ADDENDUM NO. 2
(4 Pages of text, 10 pages of attachments / Total = 14 Pages)

TO THE DRAWINGS, SPECIFICATIONS AND CONTRACT DOCUMENTS FOR:

Fairfield County
Sheridan Center Renovations - Phase1
Comm. No. 2024149.01

1 FIRST FLOOR POWER PLAN
E201 1/8" = 1'-0"

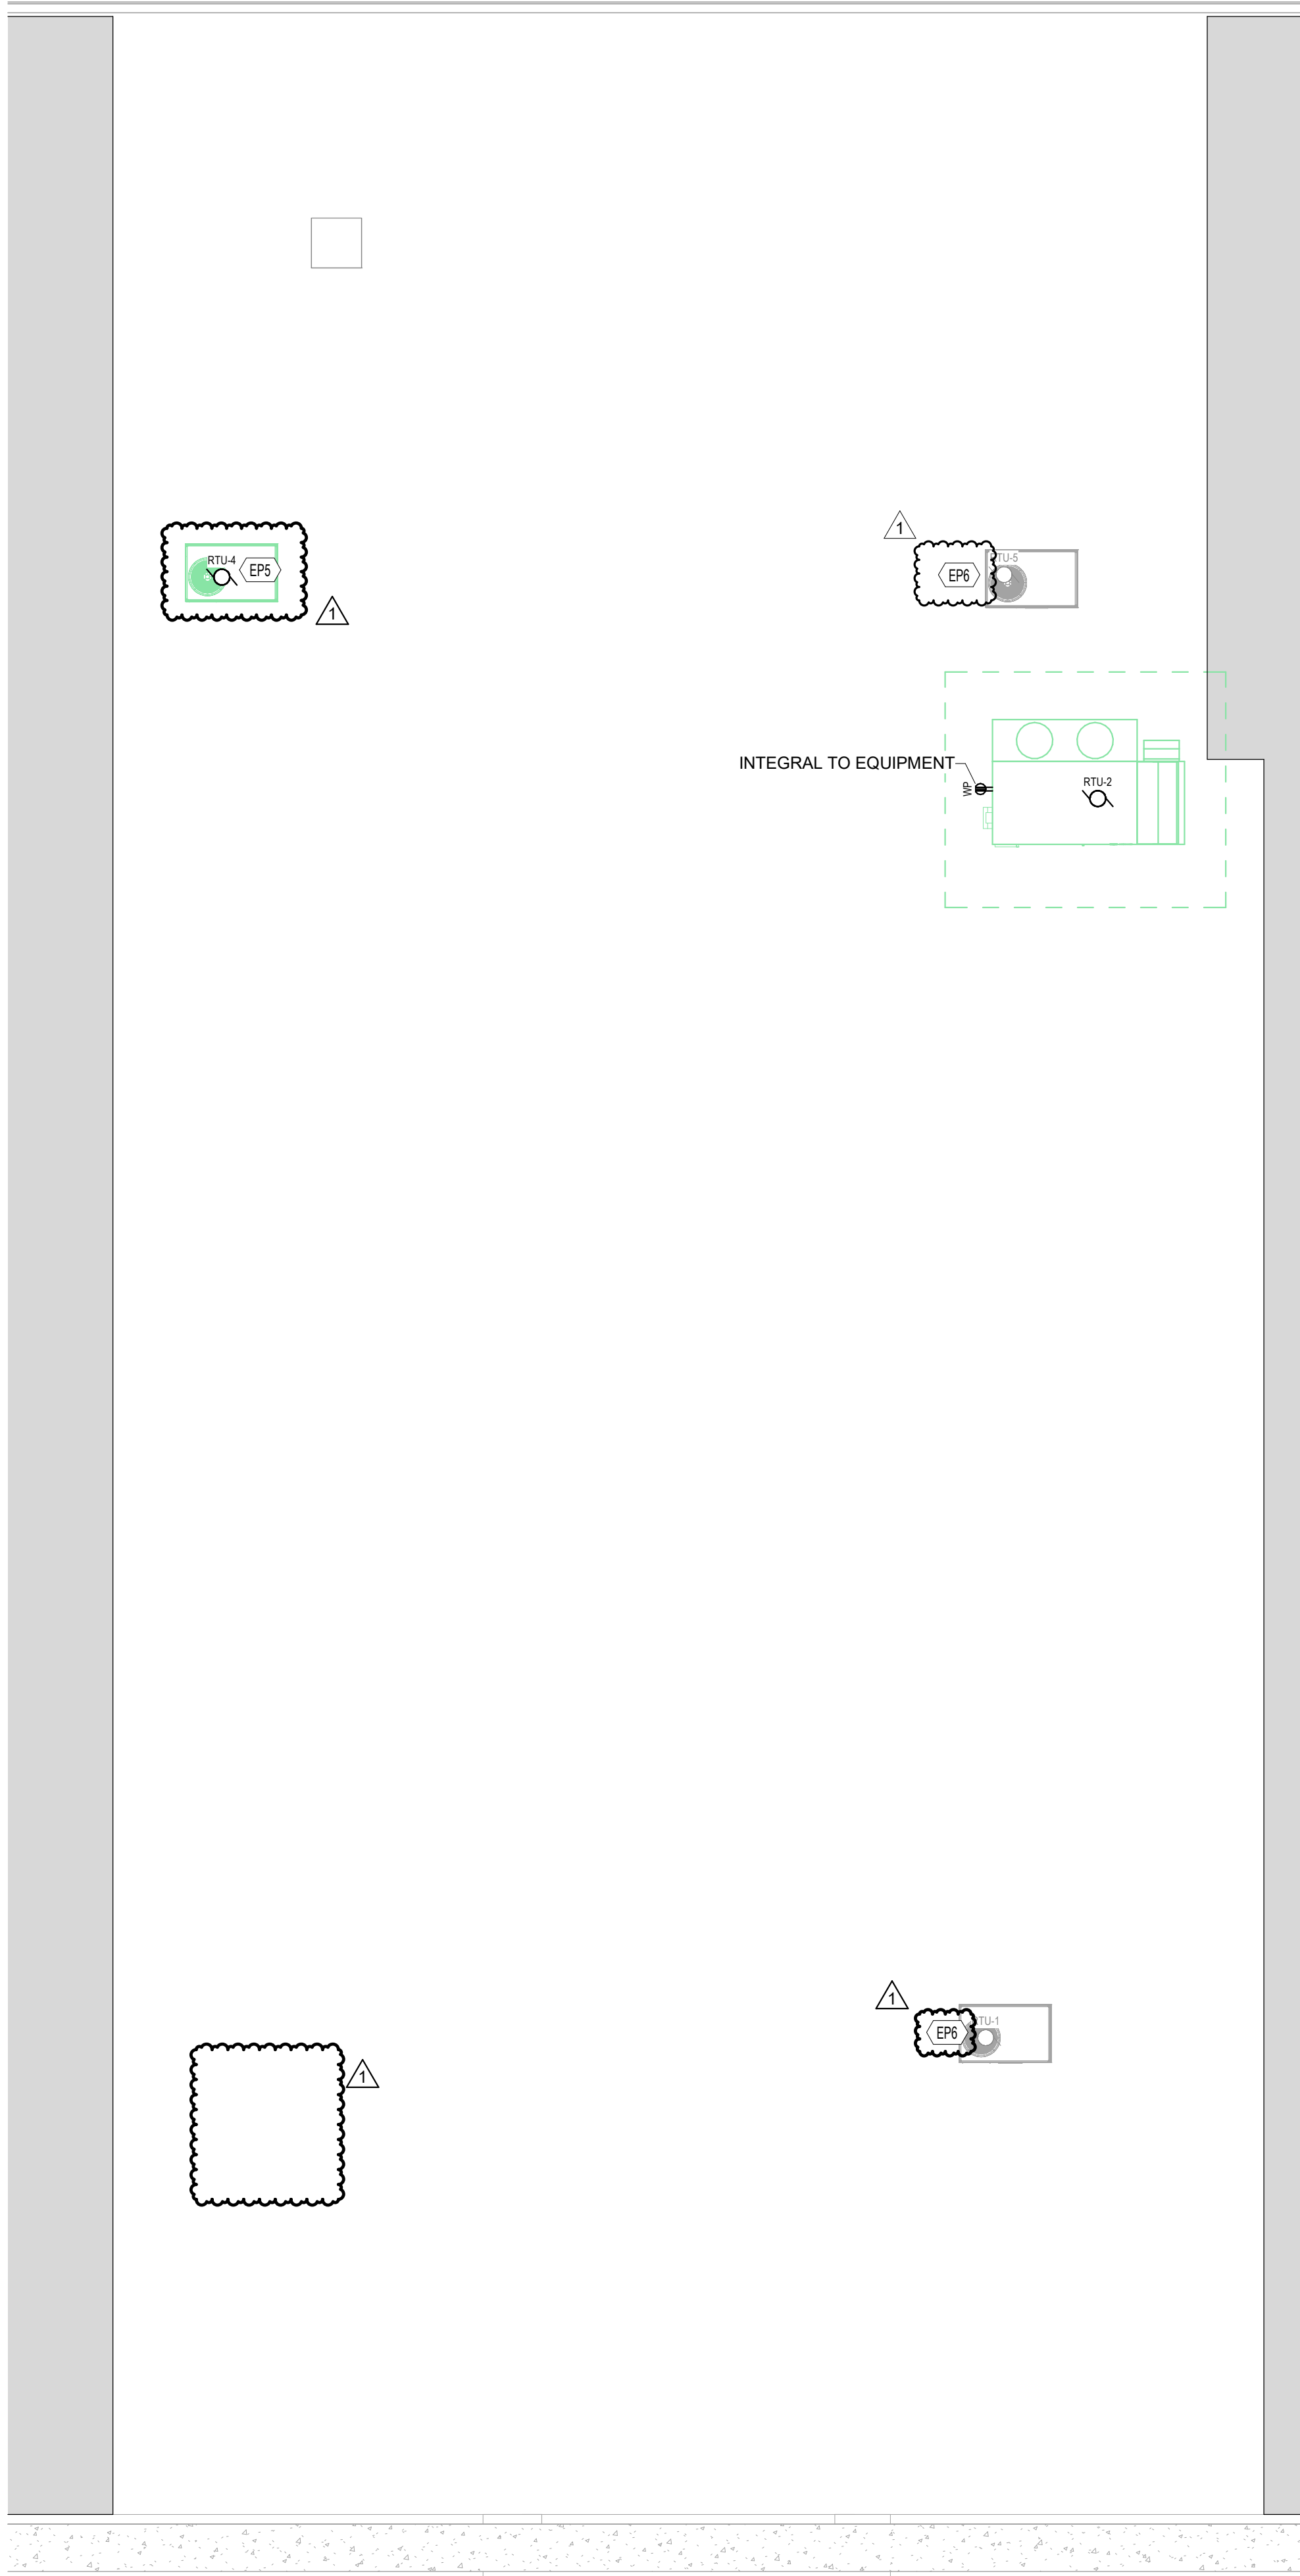
- A. Revised roof demolition plan for clarity of demolished mechanical units.
 - B. Added keynotes ED7, ED8, ED9.
- 8. **SHEET E201 – Electrical Power Plans (Re-Issued):**

- A. Revised roof power plan for clarity of demolished mechanical units.
- B. Added relocated RTU.
- C. Added keynotes EP5, EP6.

1 CANOPY DEMO PLAN - ALTERNATE
E401 1/8" = 1'-0"

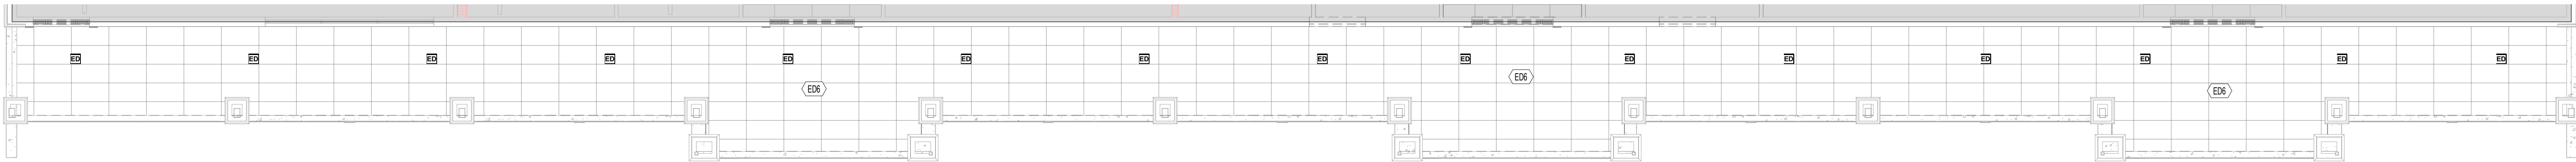
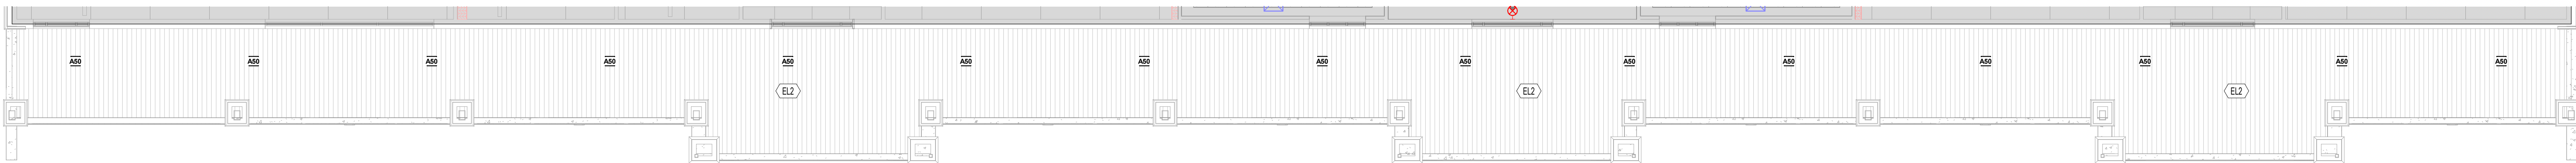
9. SHEET E401 – Electrical Alternate Plans (Re-Issued):

- A. Updated alternate light fixture schedule with approved manufacturers.

E601

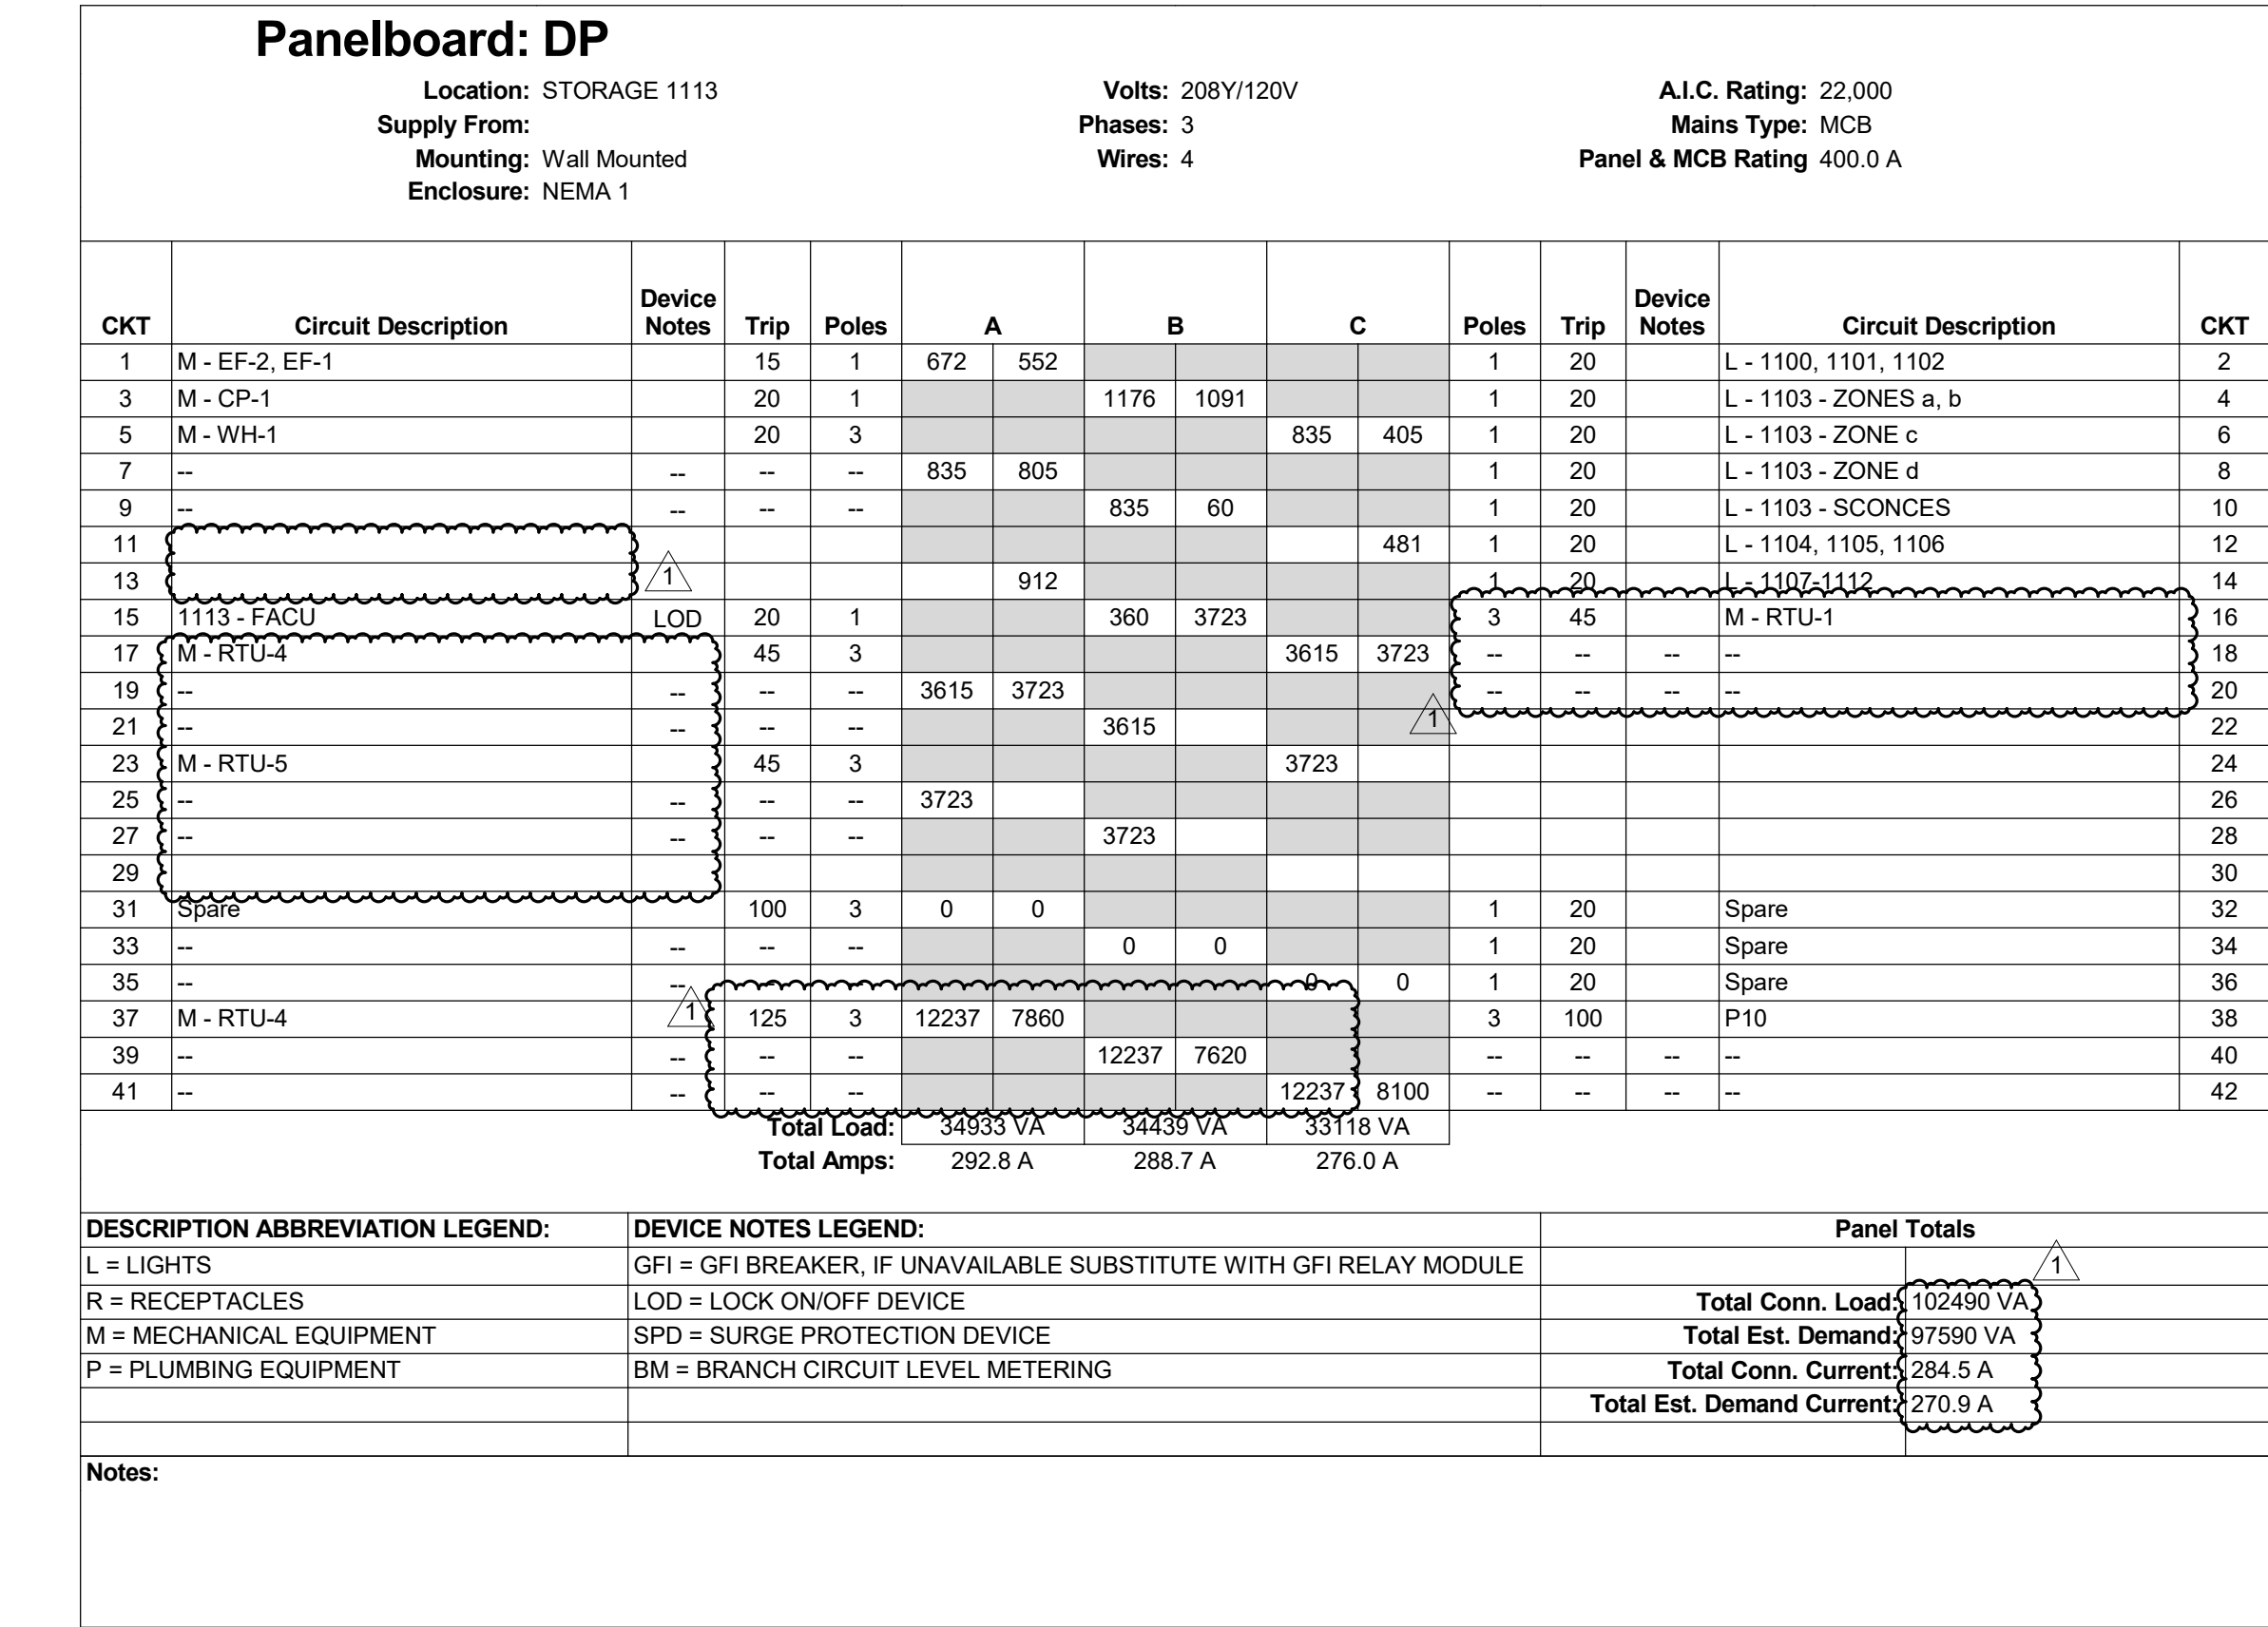
2. Which panels are RTU-1, RTU-2, RTU-4 and RTU-5 fed from? The panel schedule for Panelboard "DP" only shows RTU-4 and the one-line diagram only shows RTU-2 being fed from Panelboard "DP".

10. If a 400-amp service is required as shown on contract document E601, then a CT cabinet will also need to be installed. Please advise.

10. SHEET E601 – Electrical Single Line Diagram and Panel Schedules (Re-Issued):

- A. Updated Single Line Diagram with revised RTU-2 feeder.
- B. Revised Electrical Service Calculations with updated load information.
- C. Revised panel schedule 'DP' with updated RTU-2 load and breaker.
- D. Added RTU-4, RTU-5, and RTU-1 to panel schedule 'DP'.
- E. Removed ductless split unit from panel schedule 'DP'
- F. Removed rooftop receptacle from panel schedule 'P10'.

Answer: RTU-1, RTU-2, RTU-4, and RTU-5 to be fed from panelboard "DP".
3. Will all four of the existing electrical panels, the associated conduit and wire, the disconnect for the X-Ray machine and its associated conduit and wire be removed by the owner's demolition crew

Answer: The Design intent is to install a high-capacity meter. Coordinate exact installation requirements with the utility company.
